**Job No:** 2023-4934  
**File Ref:** N01-SG-Response to Highways (231130)  
**Date:** 30<sup>th</sup> November 2023  
**Job Title:** Land to the rear of 726 Field End Road, Ruislip

**Subject:** Response to Highways Request for Information  
 Planning reference 77818/APP/2023/300

## Swept Path Analysis Using a 13.4m Articulated Vehicle

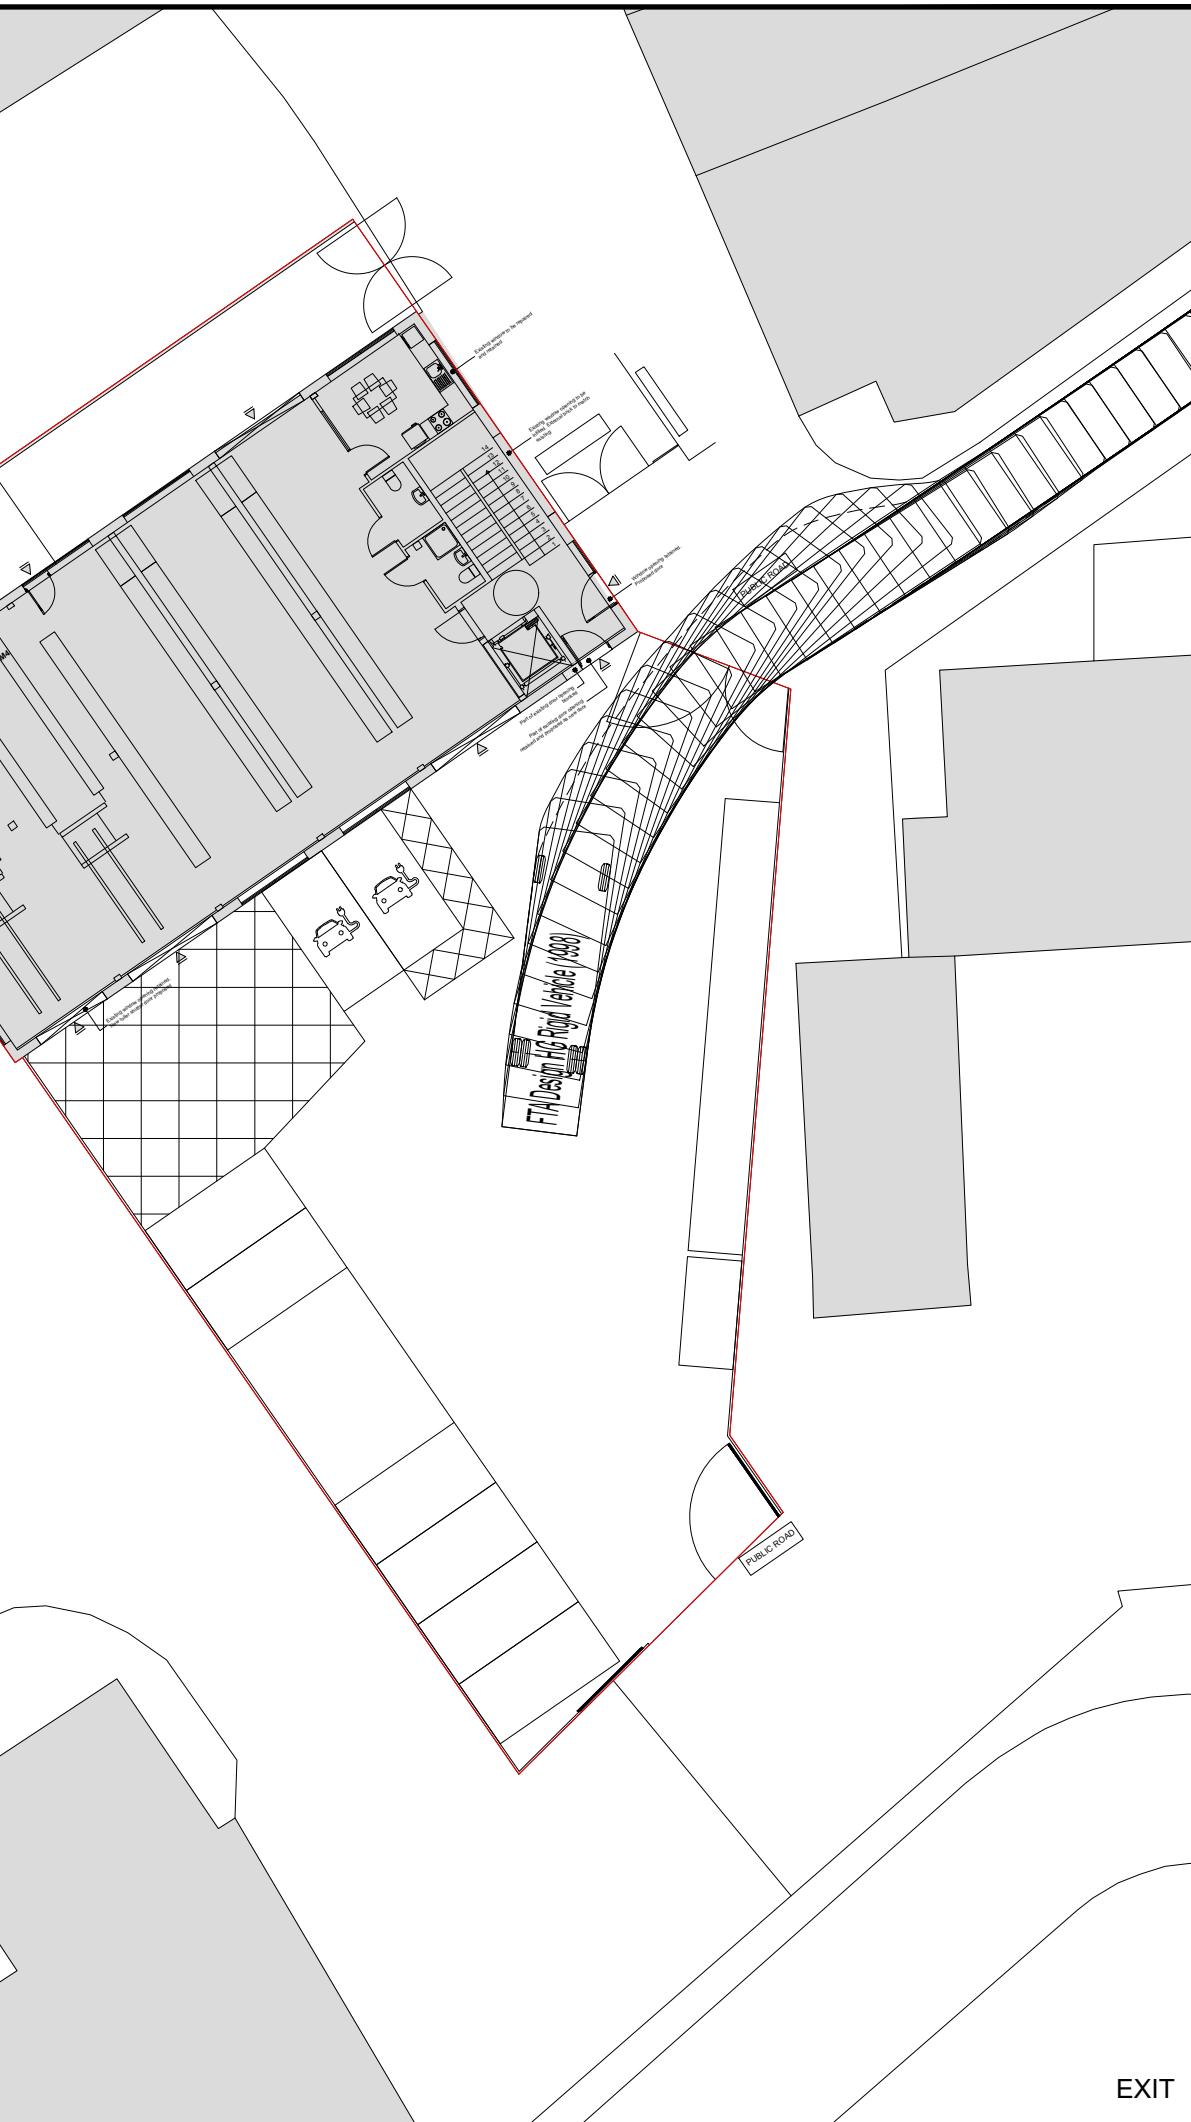
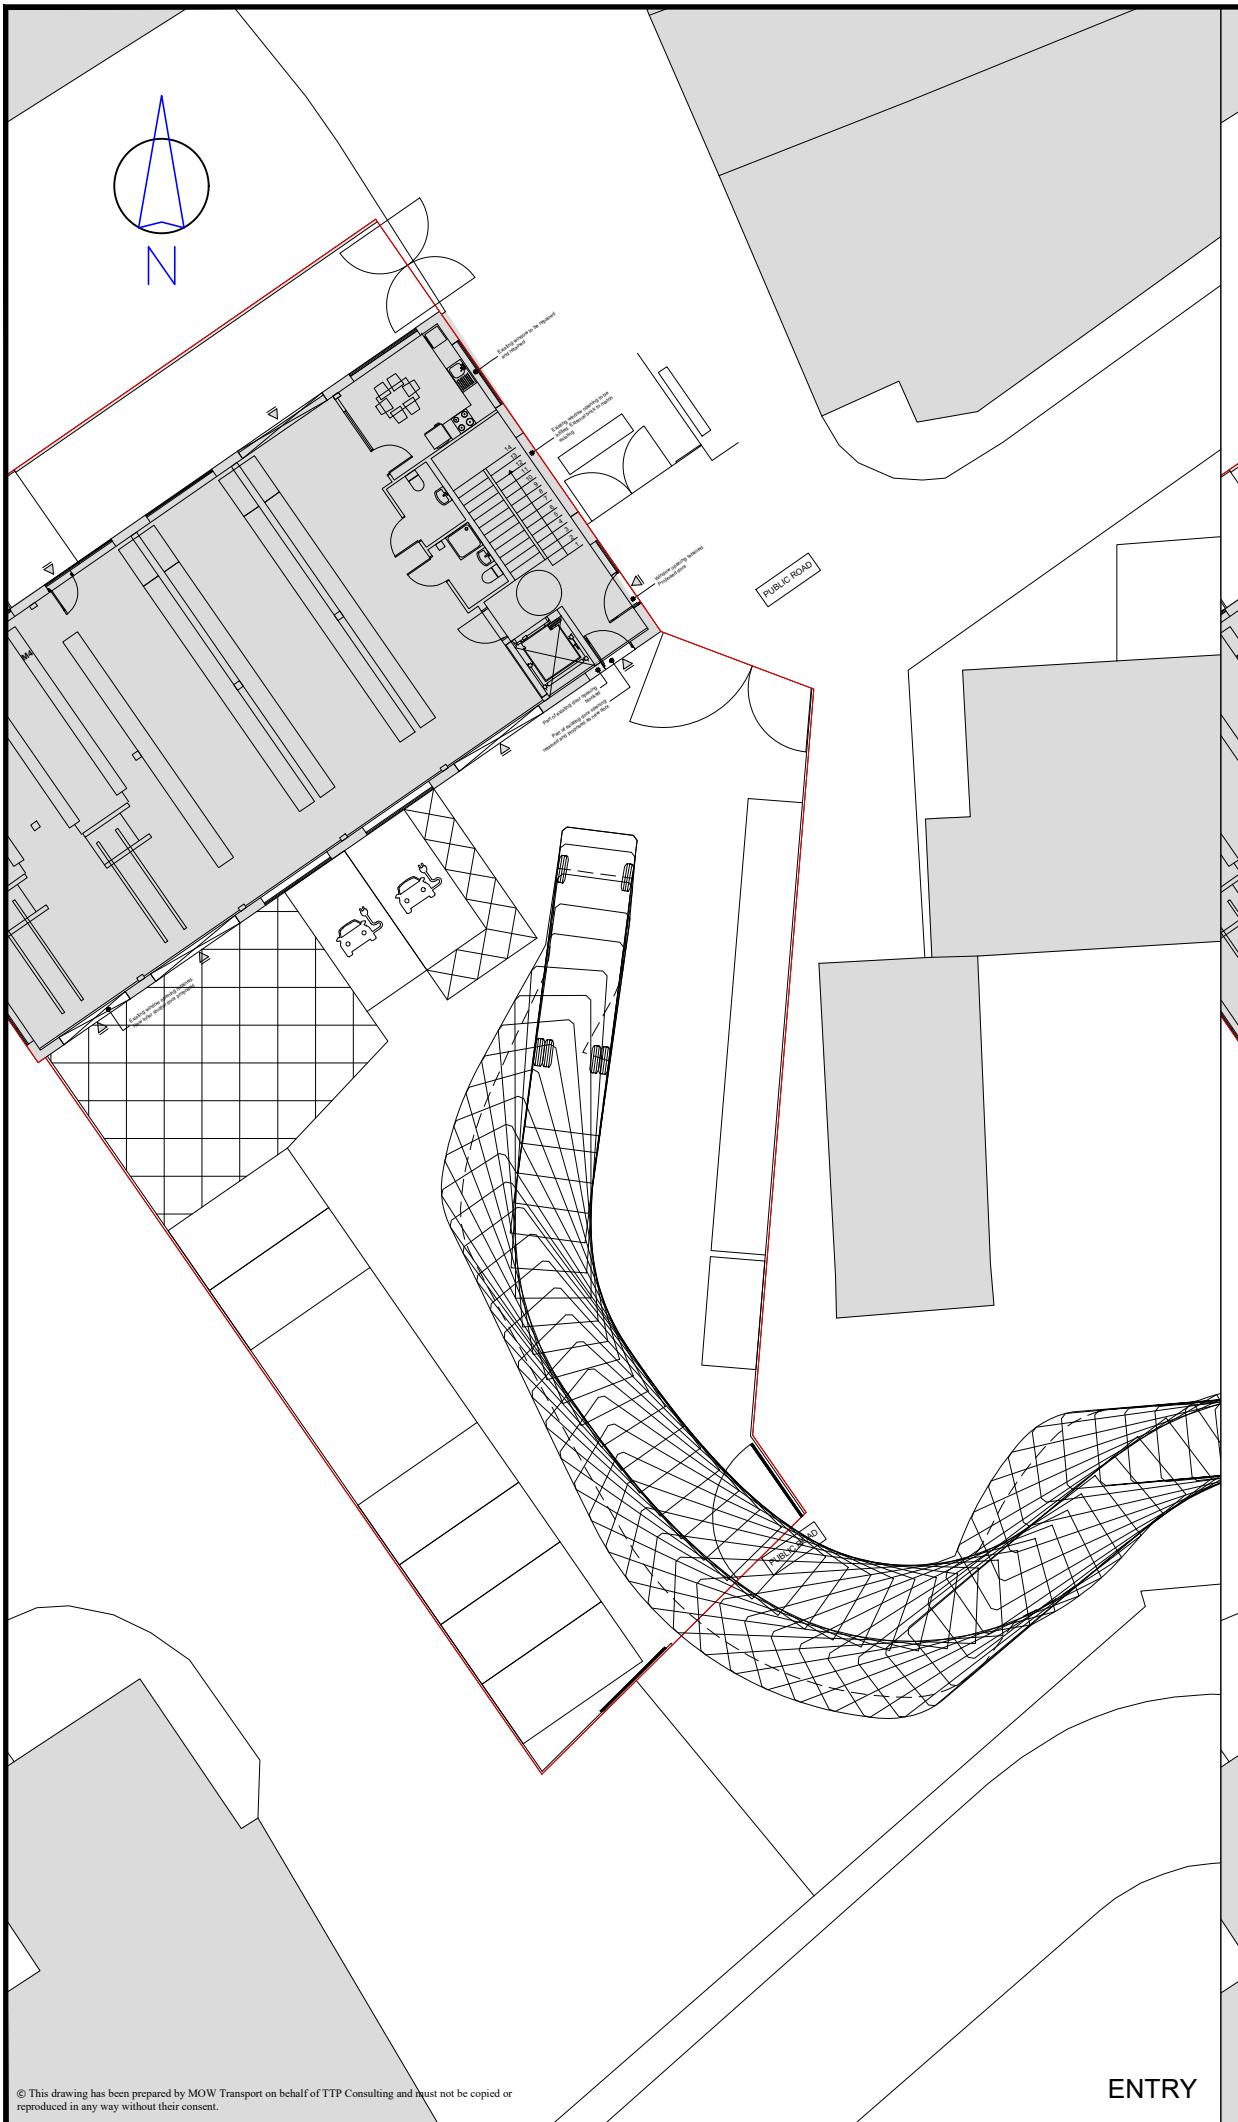
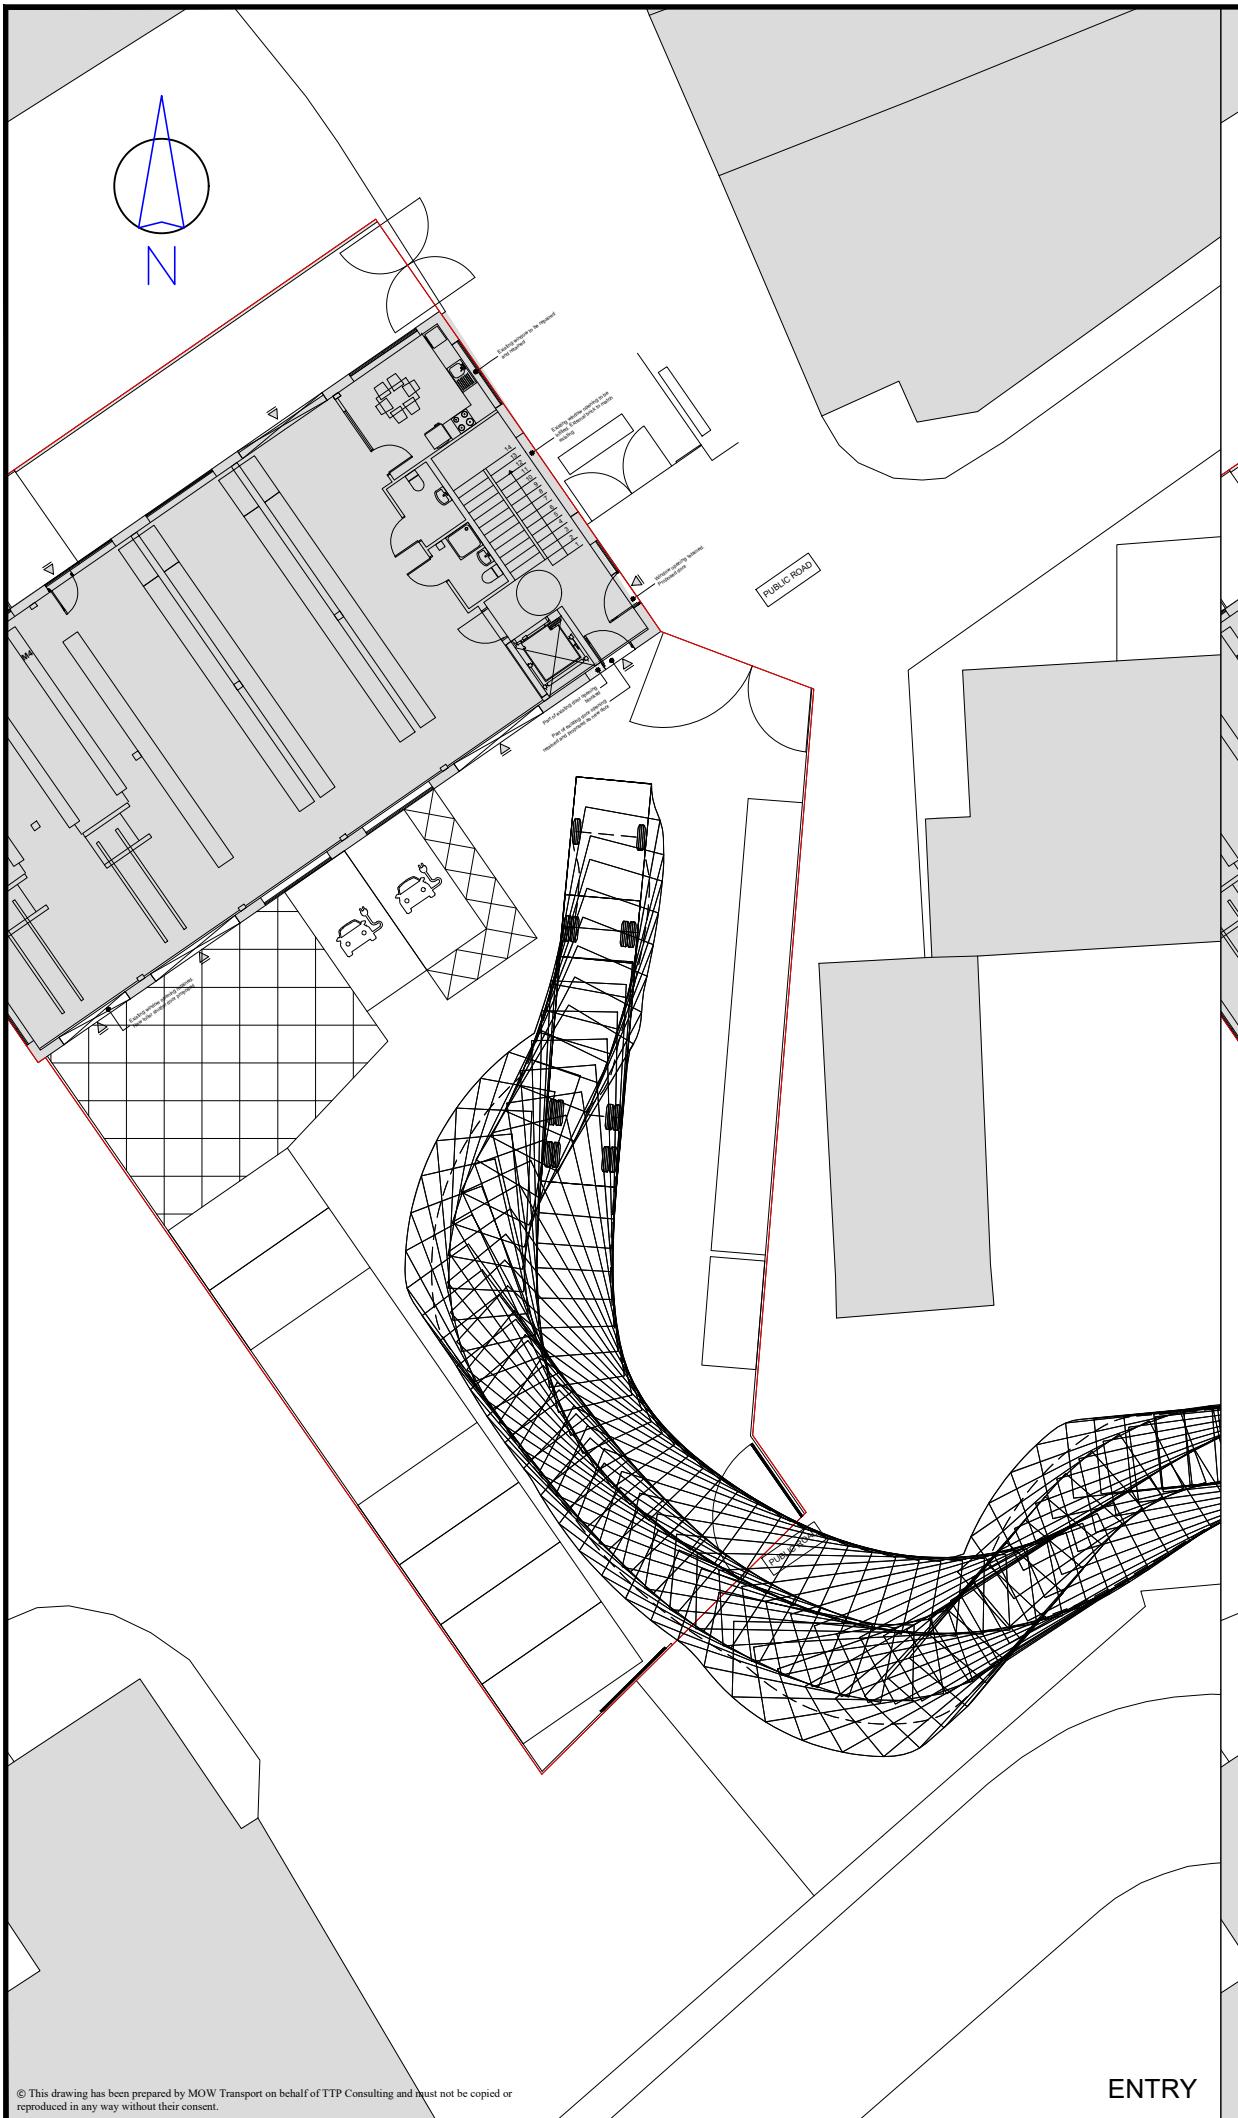
Detail of daily vehicular activity (including peak morning & afternoon traffic periods) to and from the site has not been presented, hence an informed decision cannot be actioned.

8. There will be a single weekly delivery of goods by a 13.4m curtain sided articulated vehicle. This delivery will be managed to allow the vehicle to offload in the yard. The vehicle will enter via the southern gate and exit the site in forward gear via the northeastern gate. The duration of stay is anticipated to be no longer than an hour, during which time, no other vehicles will enter or exit.

9. Swept path analysis has been undertaken demonstrating typical vehicle movements and this is included at **Annex D** to this note.
